**Re: Swim Labs Swim School  
8120 Ventura St. NE  
Request for Certificate of Occupancy  
Transportation Development Final Inspection  
Engineer's/Architect's Stamp dated 7-31-19 (C20D082)  
Certification dated 5-7-20**

Re: **Permanent Certificate of Occupancy for SwimLabs Swim School  
8120 Ventura Street NE**

TITLE  
**Traffic Circulation Layout**

**1 Architectural Site Plan**  
Scale: 1"=30'-0"

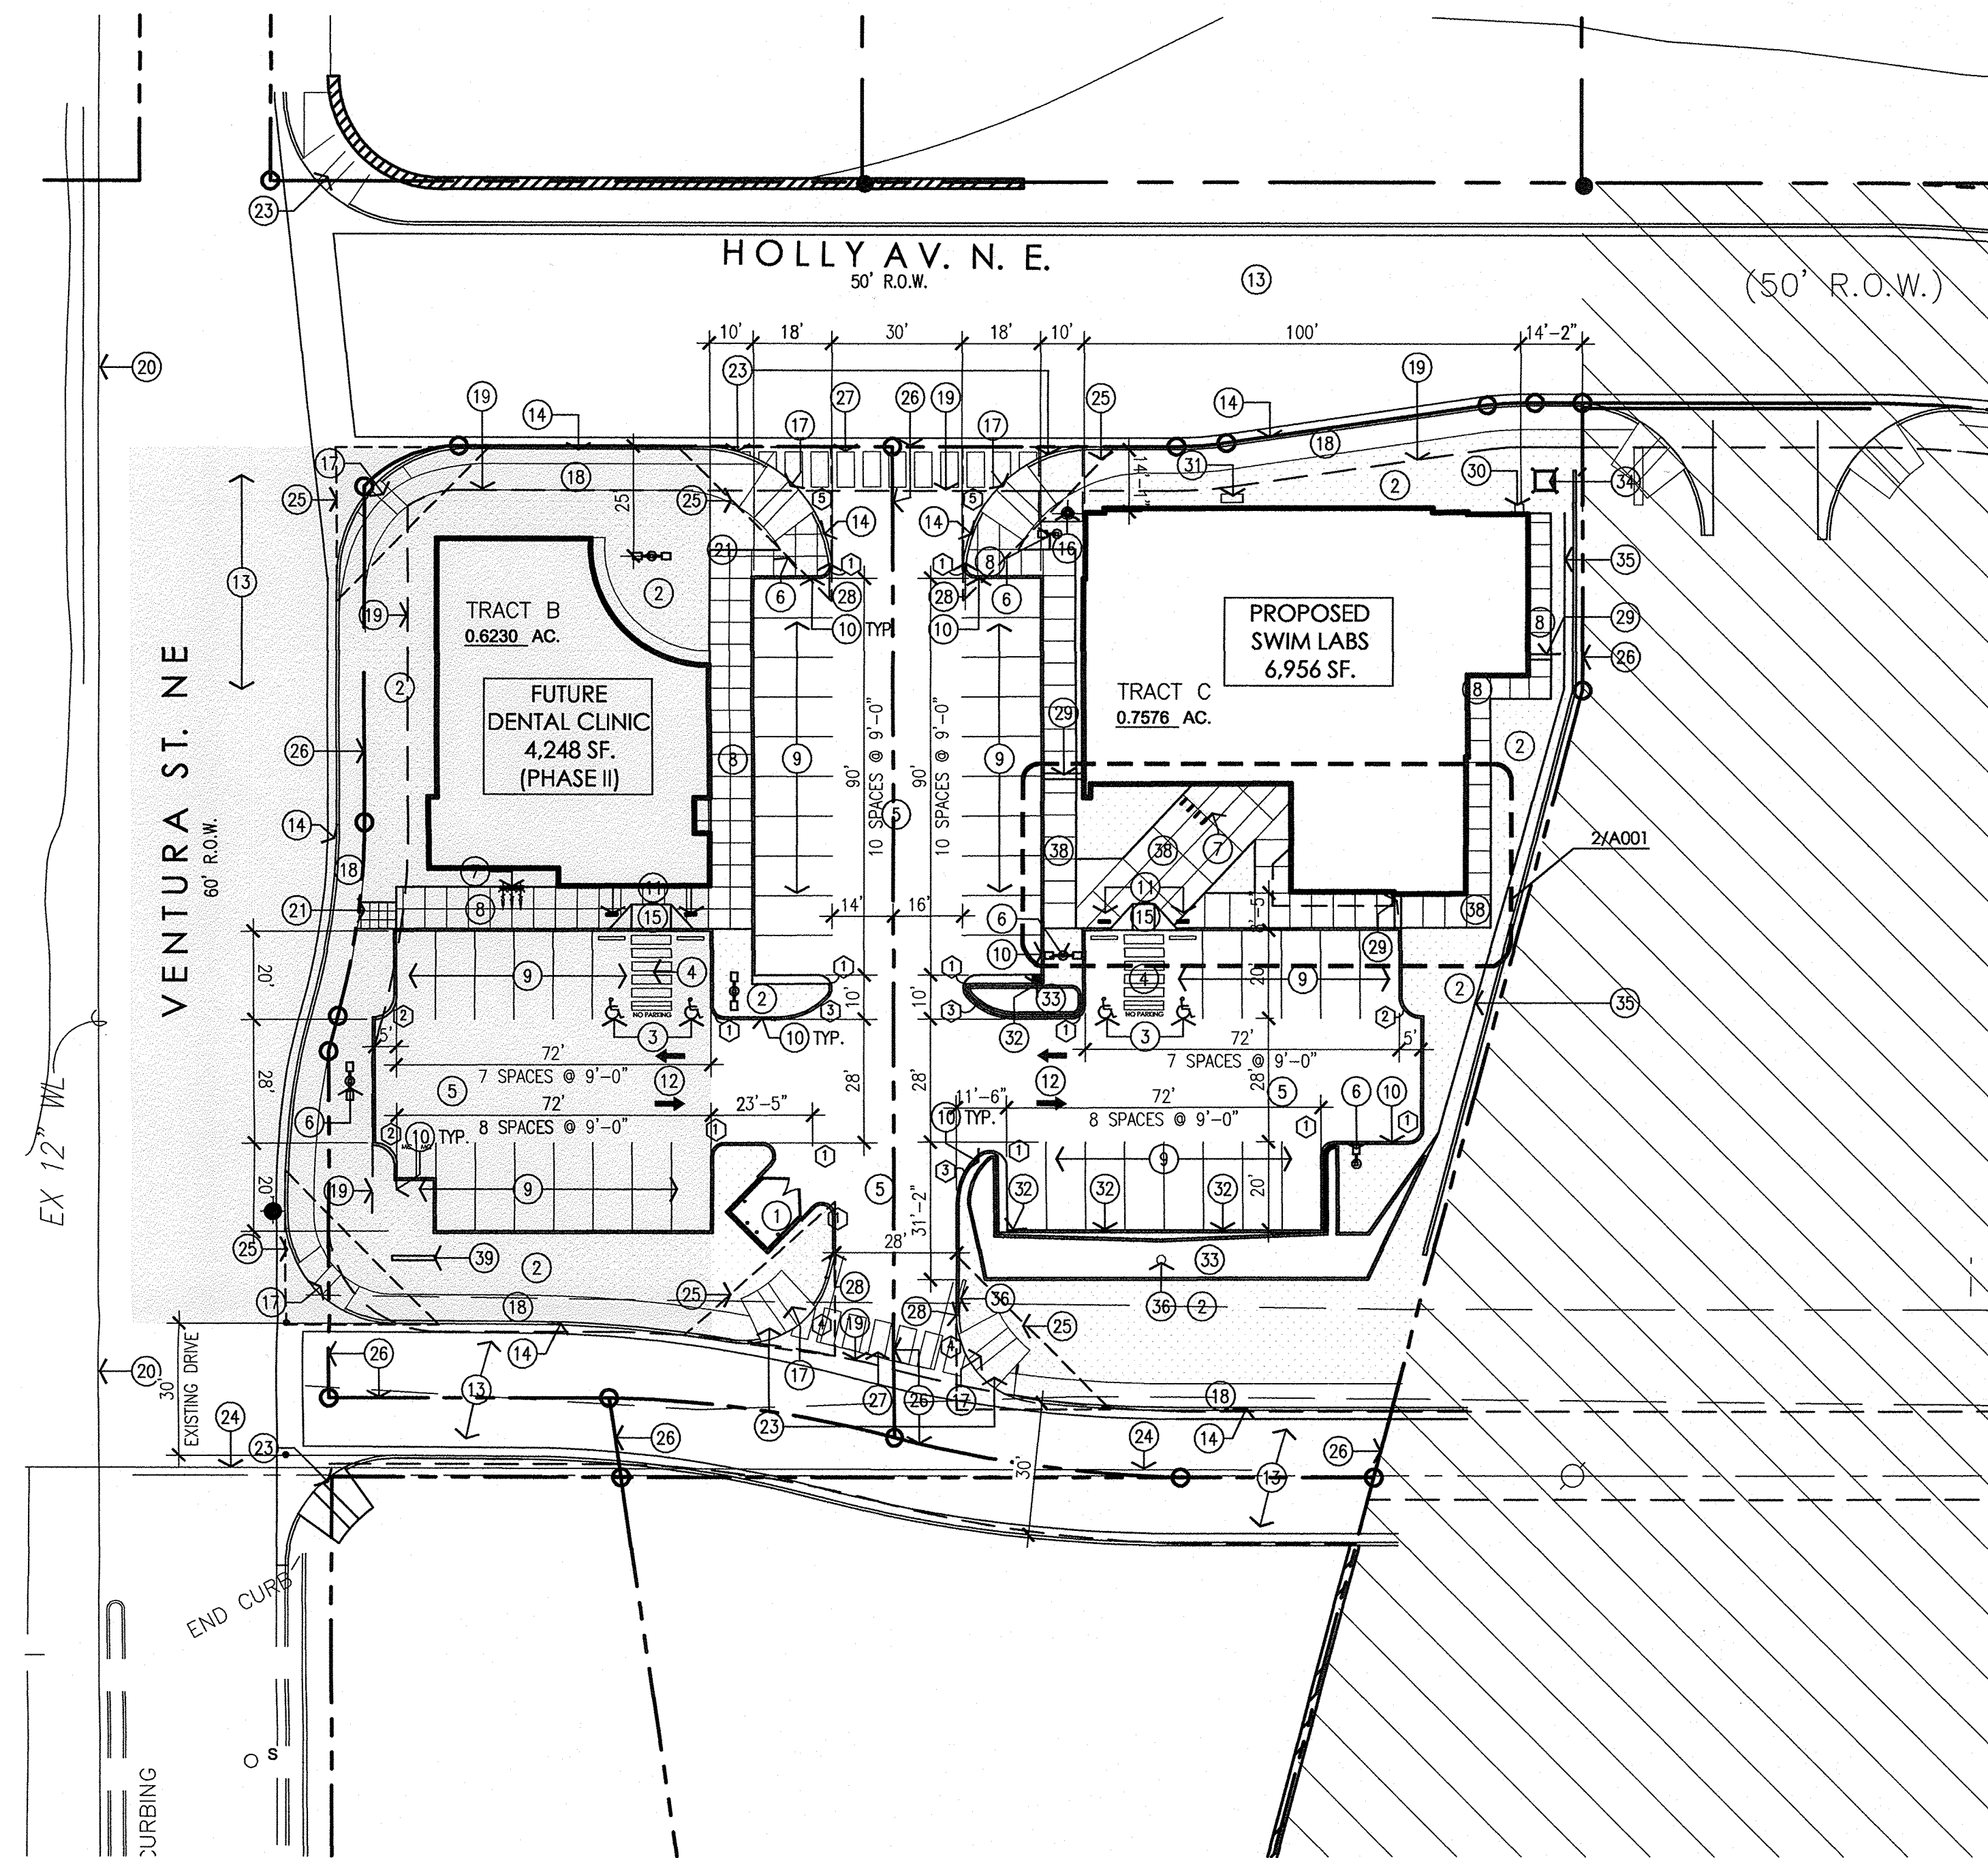
- Please add truncated domes of wheelchair ramp in public right of way.  
*Truncated domes are installed on the four ramps in the right of way.*
- Please complete sidewalk off Holley.  
*The sidewalk work was associated with the PNM transformer and is now complete.*
- Remove Fire Lane crossing over parking stall.  
*Per the Fire Marshal's request the fire lane at the end of the parking stalls are to remain to designate the fire lane through the side. At this time, the fire lane striping have not been removed. I have attached the Fire Marshal's approved Fire 1 for reference.*
- Please remove landscape materials from parking stalls.  
*All landscape material has been removed from the parking lot.*

ALL WHEELCHAIR RAMPS LOCATED  
WITHIN THE PUBLIC RIGHT OF WAY  
MUST HAVE TRUNCATED DOMES.
